FINAL DRAINAGE LETTER FOR LOT 6 OF CLAREMONT BUSINESS PARK 2 FILING NO. 1

EL PASO COUNTY, COLORADO

MARCH 2021

Project #44-037
PCD – SP 20-000

PROPOSED DRAINAGE MAP - LOT 6

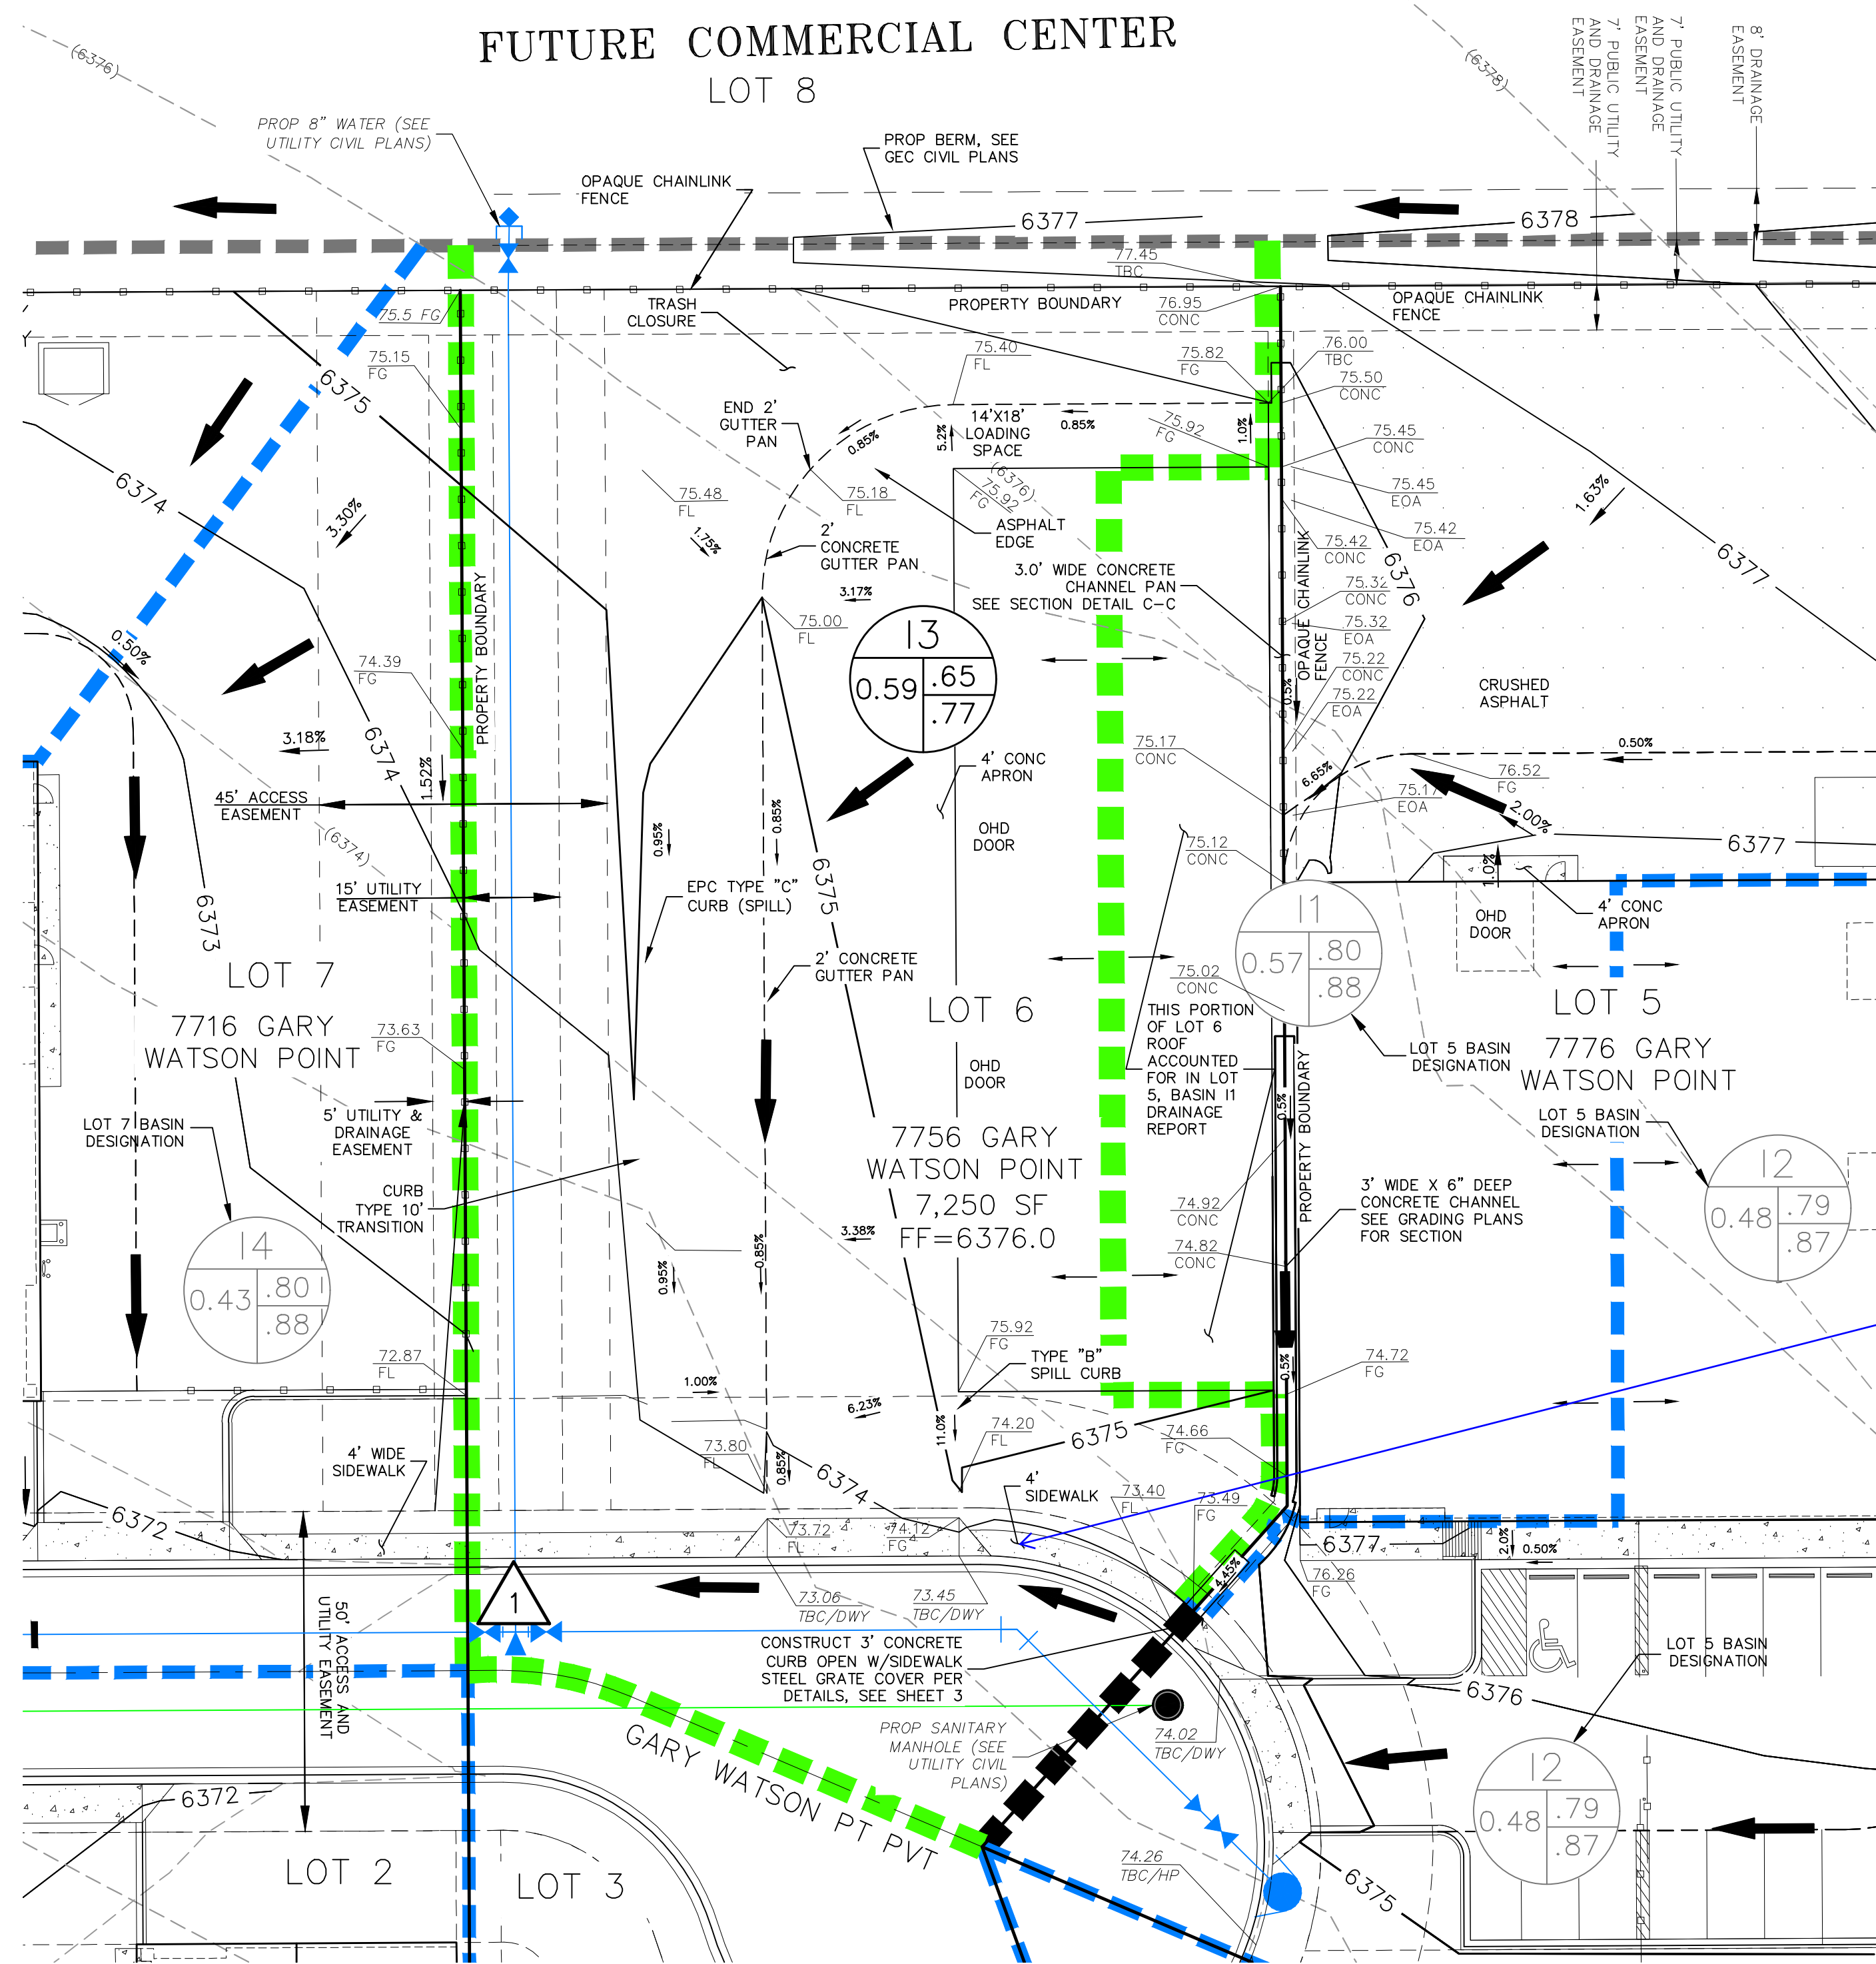
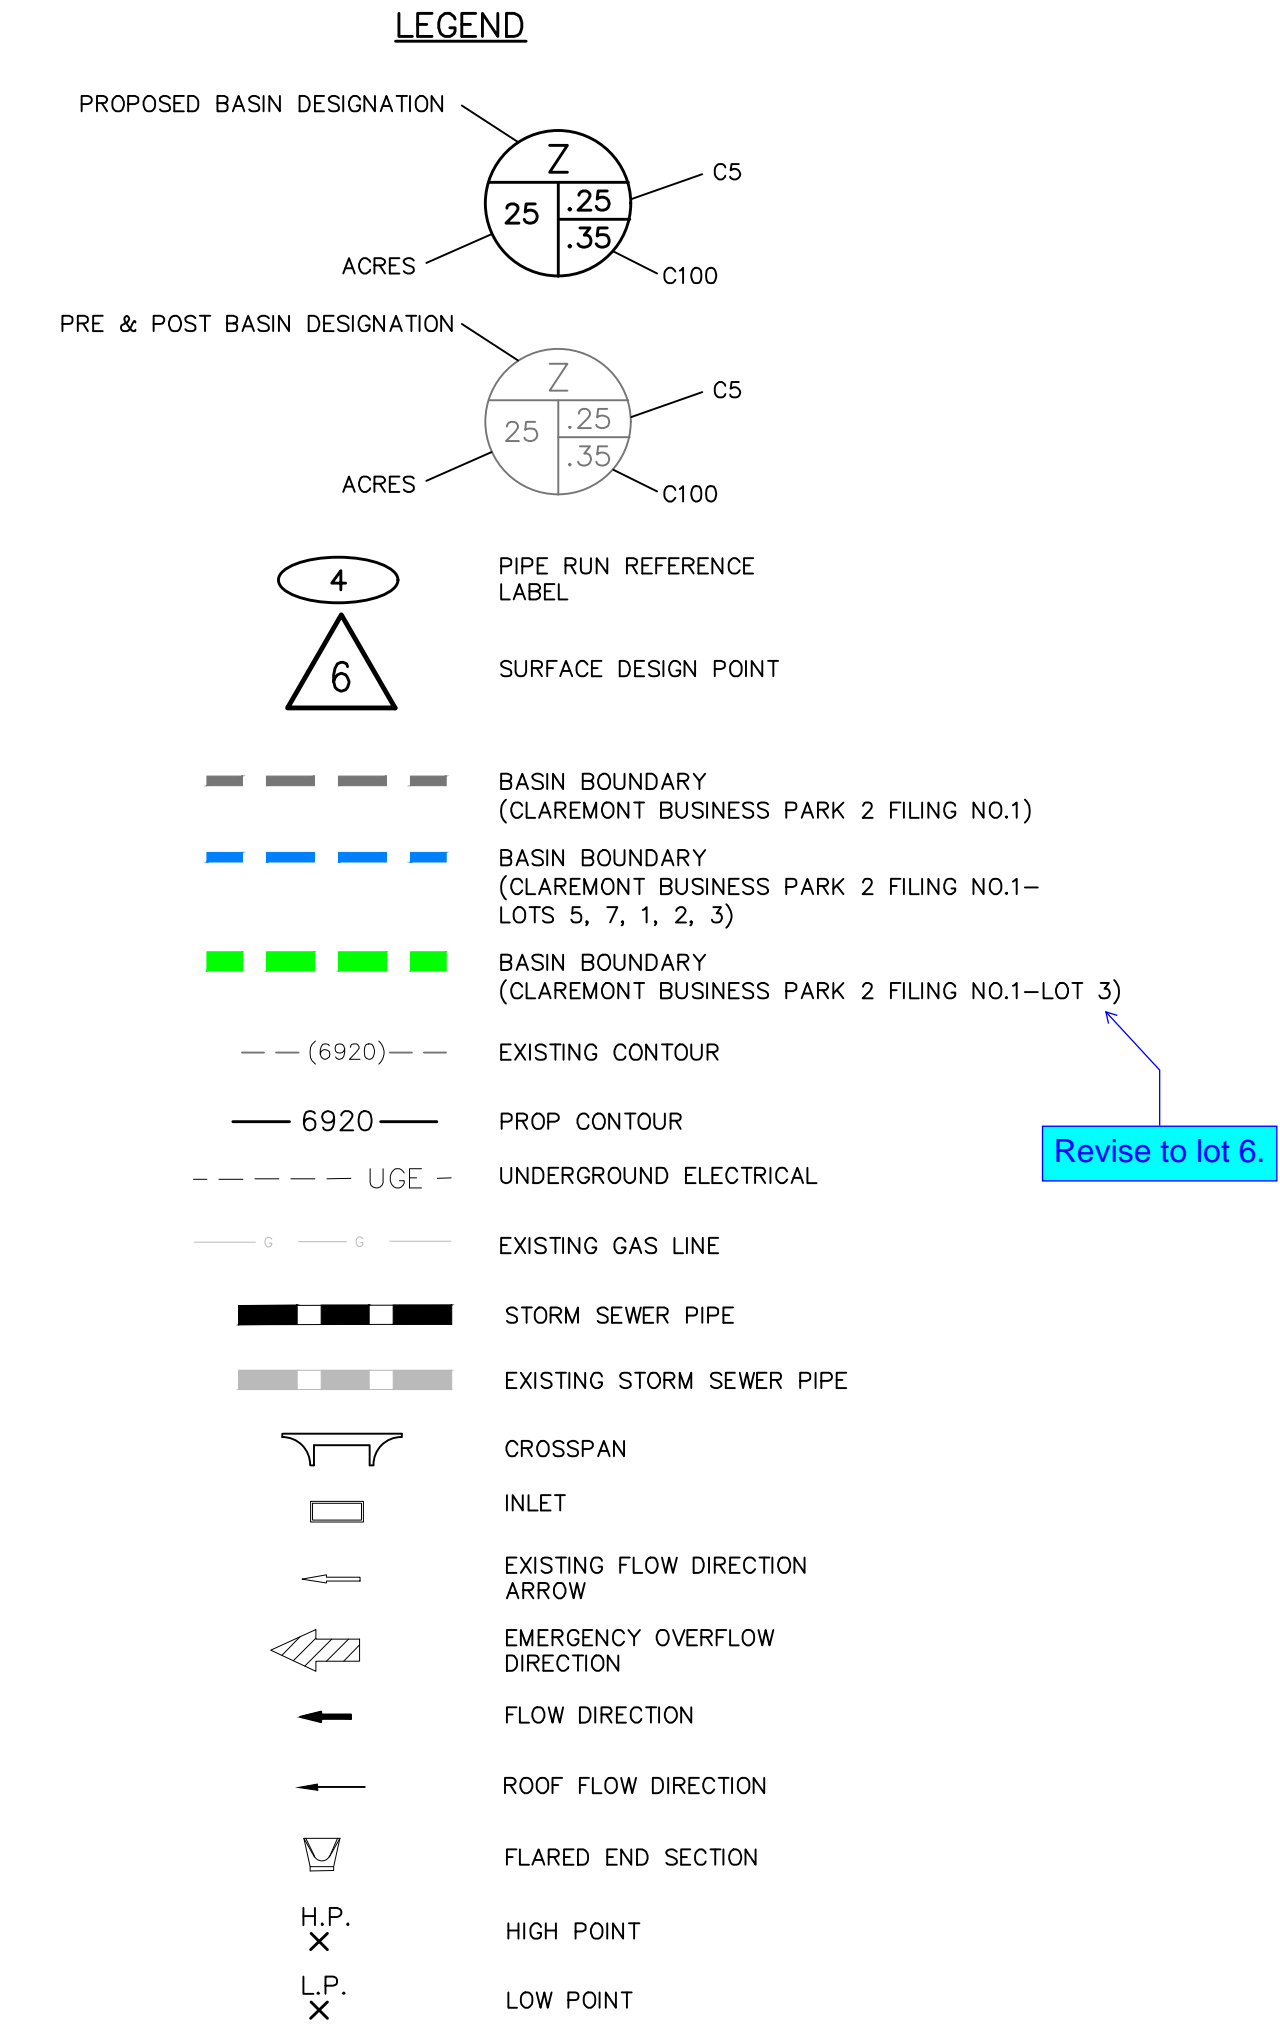
Revise to lot 6.

Revise the sidewalk to match the GEC and Site plan
